CT7-2E1 SERVICE BULLETIN - 73-0008 R00

**SB 73-0008 R00 ENGINE FUEL AND CONTROL - ELECTRONIC ENGINE CONTROL (73-00-00) -  
EECU CONNECTOR RTV ADDITION AND COVER INSPECTION**

TO: Holders of CT7-2E1 FADEC, Engine Control Unit.  
FROM: BAE Systems  
CAGE: 89954  
ILS/Product Support  
1098 Clark Street  
Endicott, NY 13760 USA  
Web: <http://www.baesystems-ps.com/customersupport>  
SUBJECT: ENGINE FUEL AND CONTROL - Electronic Engine Control (73-00-00) - EECU Connector RTV Addition and Cover Inspection CT7-2E1-73-001, Revision 0, dated Mar 04/2024

# SERVICE BULLETIN

Connector and PWB Edges To Be Bonded  
Figure 2

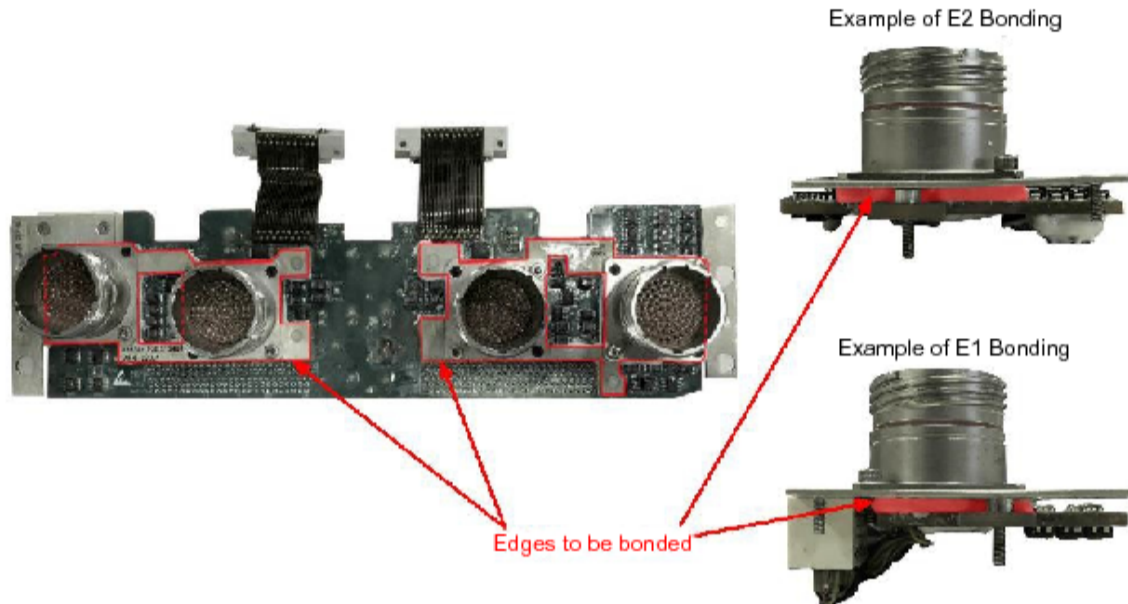
- (a) Inspect for presence of foreign object debris in the area around the exposed J1, E1, J2 and E3 connector pin fields and clean area as necessary. Refer to CLEANING section of CMM 73-21-95.
- (b) Inspect for presence of bonding material along the perimeter edge of the four electrical connector mounting plates. Bonding locations prior to this service bulletin are shown in [Figure 1](#).
- (c) If bonding material is not present at all locations shown in [Figure 2](#), apply adhesive bonding material as follows:

Using a syringe with a small opening, neatly apply bonding material (TSE-322 and RTV-6424 or an equal mixture of 3140 and 3145 RTV) between the connector mounting plates and the PWB along the exterior and interior perimeter edges of the mounting plates or PWB edge to prevent FOD from entering pin fields as shown in [Figure 3](#). Refer to the GENERAL PRACTICES MANUAL, Section 73-45-18, for RTV bonding application procedures.

New RTV Application Locations  
Figure 3 (Sheet 2 of 7)

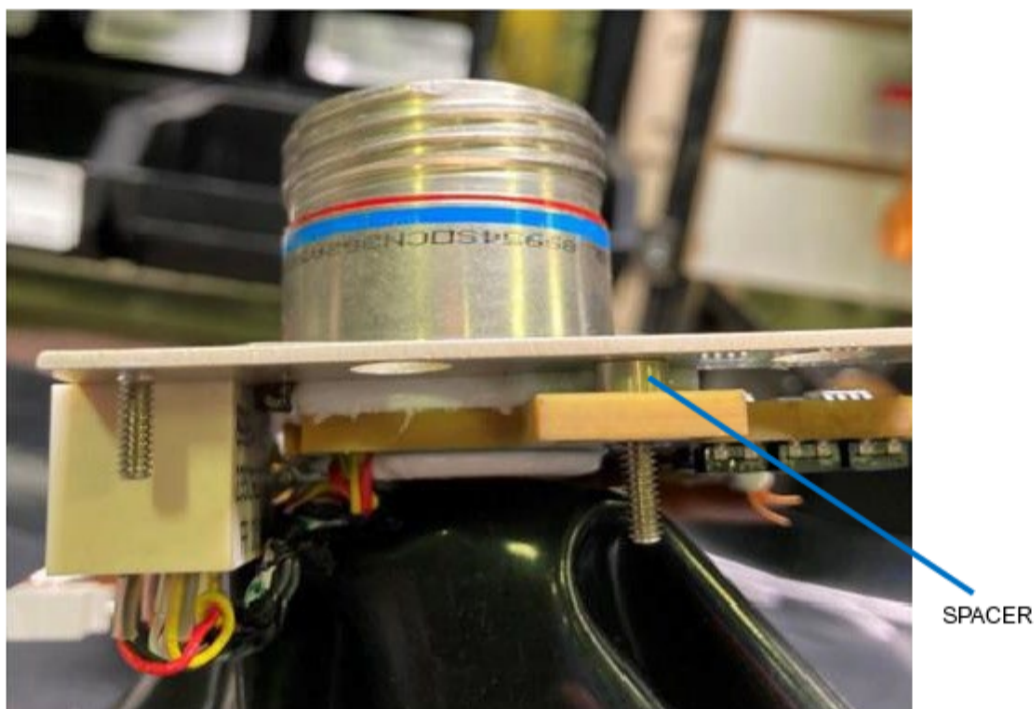
**CAUTION:** MAKE SURE SPACER IS NOT ENCAPSULATED WITH RTV.

New RTV Application Locations  
Figure 3 (Sheet 6 of 7)

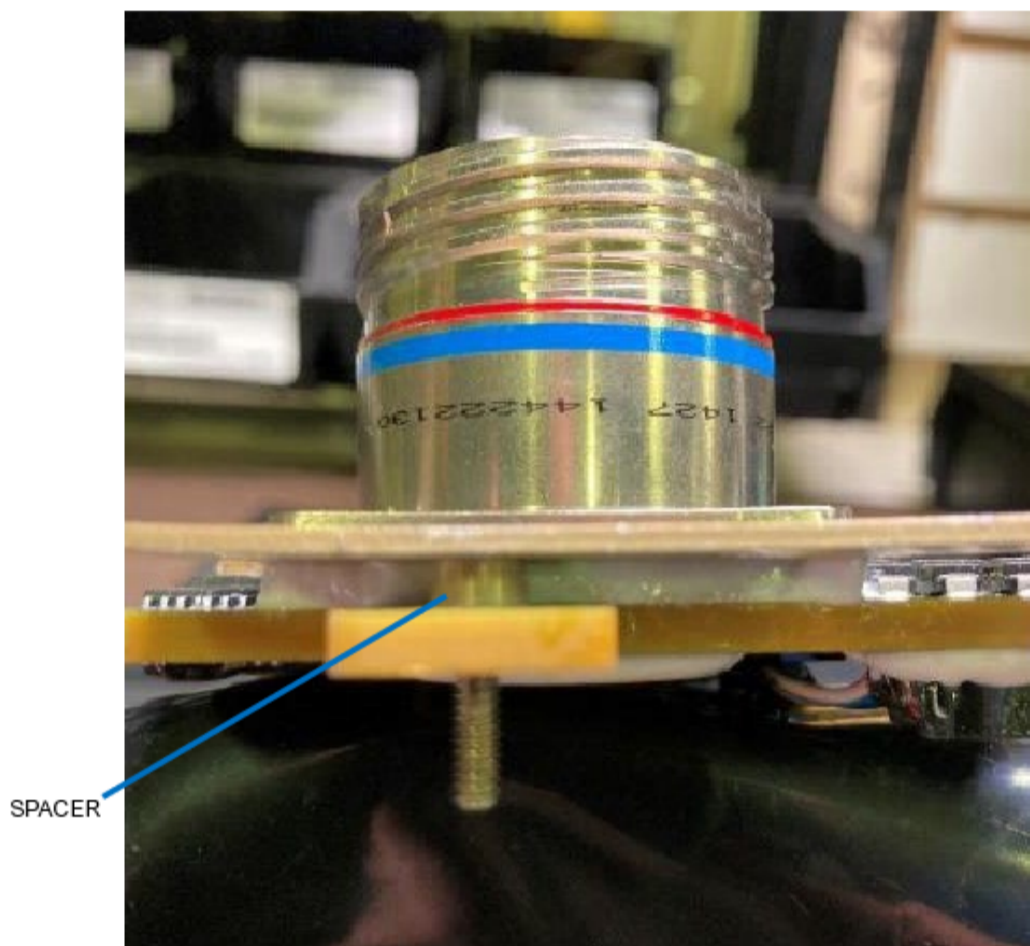
CAUTION: MAKE SURE SPACER IS NOT ENCAPSULATED WITH RTV.

Cover Flatness Deviation Inspection  
Figure 4 (Sheet 1 of 3)

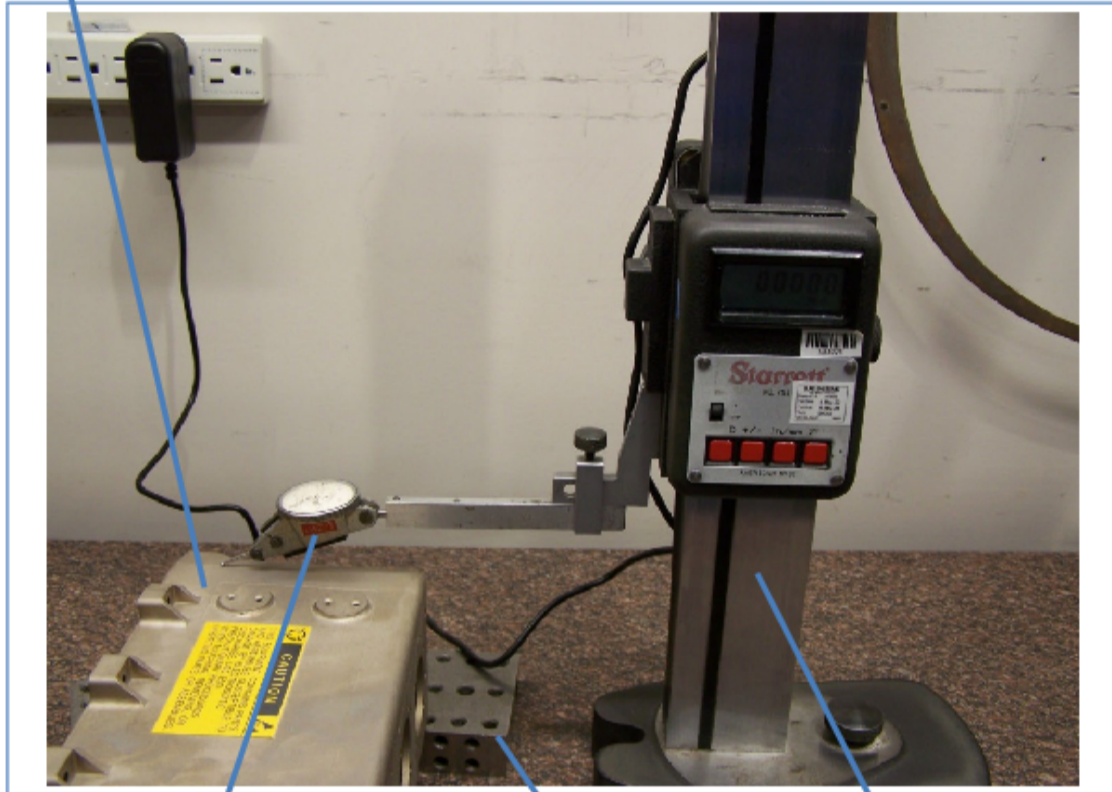
- (a) Place EECU cover on a level work surface, on its long side with the opening facing away from the height gauge and the ID plate facing upwards. Refer to [Figure 4](#), ([Sheet 1](#) of 3).

NOTE: The mounting flanges on the cover will prevent it from sitting level, so the cover will need to be elevated from the table using four leveling blocks to ensure a parallel plane exists between the cover surface and the height gauge.

Measure Flatness  
Deviation Across  
Length of Exterior  
Surface  
(0.056 in. Maximum)

**NOTE:** Due presence of mounting flange, cover must be raised off of table surface using leveling blocks to create a parallel plane between cover surface and height gauge.

Cover Flatness Deviation Inspection  
Figure 4 (Sheet 2 of 3)

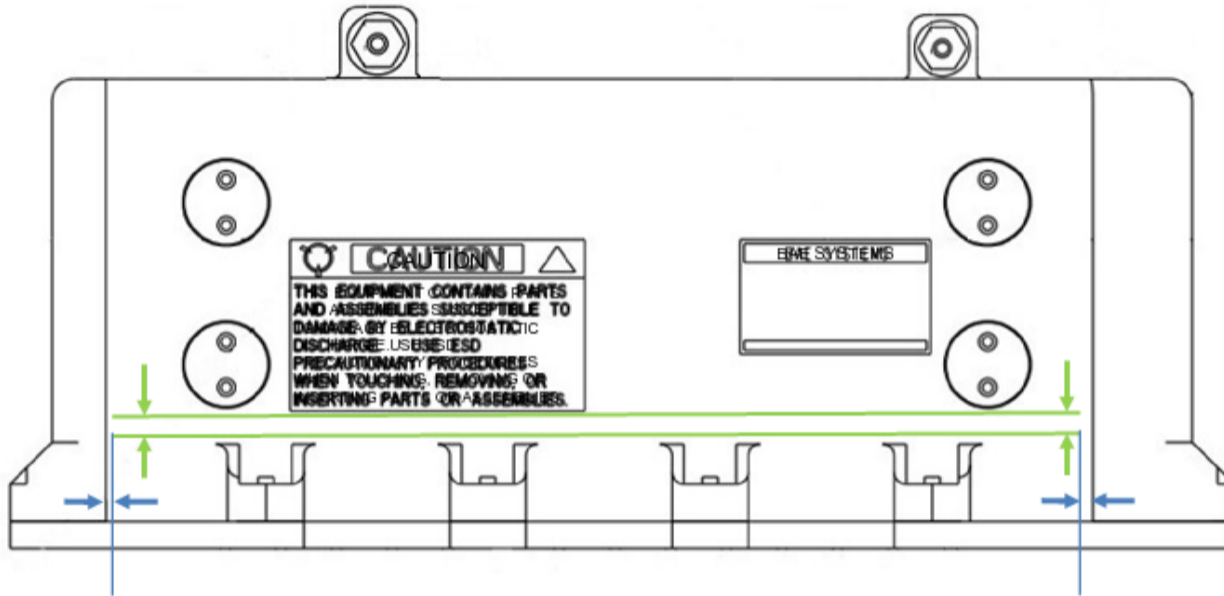
- (b) Using a height gauge, run across the exterior surface of the cover and measure the flatness deviation within the area shown in [Figure 4](#), ([Sheet 2](#) of 3).

**NOTE:** Measure across the top of the cover within the green outlined area.

**NOTE:** Starting and ending points of measurement should be approximately 1/8 in. to 1/16 in. from the crease in the cover.

Service Bulletin Stamp Location  
Figure 5

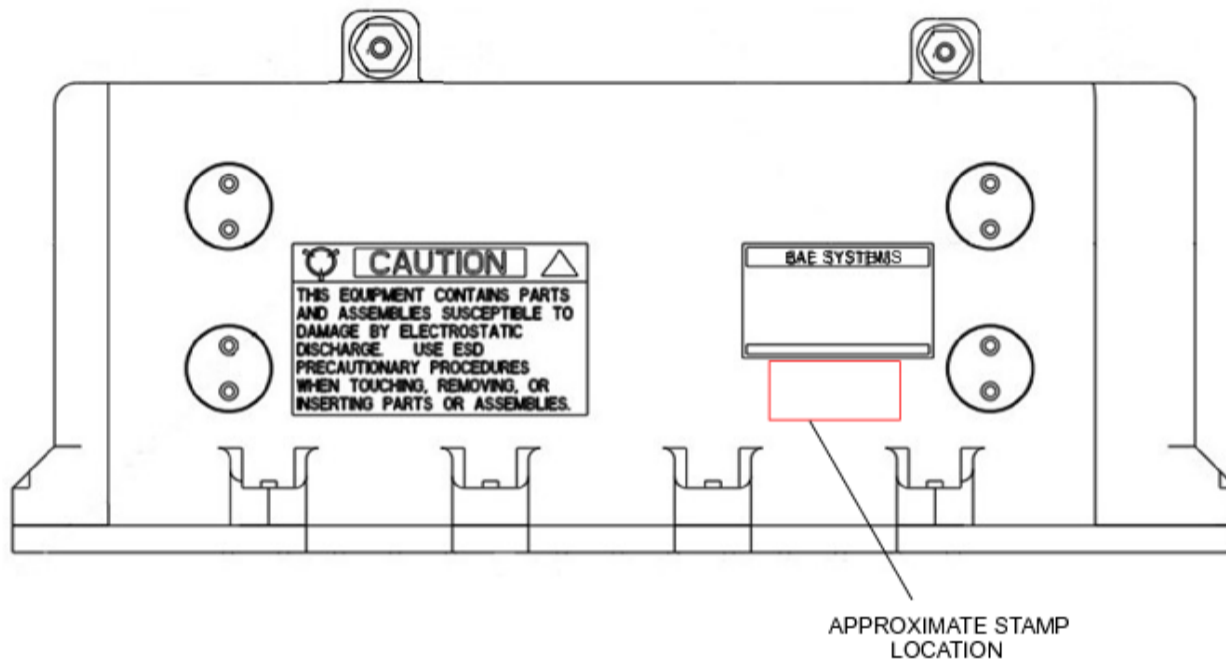
The CT7 FADEC does not contain a Service Bulletin ID Plate. Please mark with a stamp and epoxy ink per GPM 73-30-16. Refer to [Figure 5](#) for stamp location.

Mark Location with: SB 73-0008
